Number..... MH0101
 Date October 25, 2001
 Ride type..... MATTERHORN
 Serial No. All Models

MANDATORY SAFETY BULLETIN

SUBJECT: REPLACEMENT OF LOCK-NUTS ON CONNECTION POINT OF GONDOLAS TO THE RADIAL ARMS.

DESCRIPTION OF MODIFICATION REQUIREMENTS

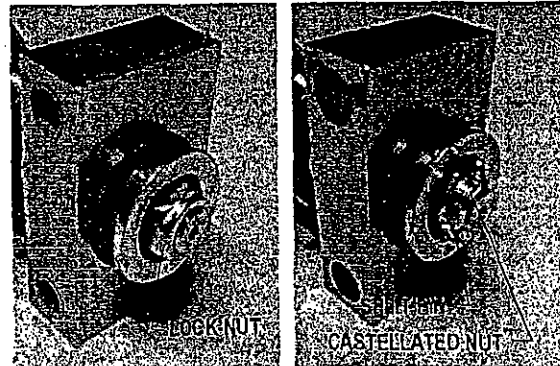
All Lock-nuts (total q.ty 40 pieces) holding the articulated supporting blocks connecting the cars to the radial arms are to be replaced by Castellated nuts and split pins.

Before proceeding for replacement, all cars have to be disconnected from the supporting blocks.

As soon as both lock-nuts on the same radial arm have been replaced, a 4,25 mm. (11/64") hole have to be drilled and a 40x4mm (1 1/2x5/32") split pin have to be installed.

New Castellated nuts:

- Syze: M20x1,5 (fine pitch)
- Grade: 5.6
- Standard: UNI 5593
- Torque: 180 Nm.
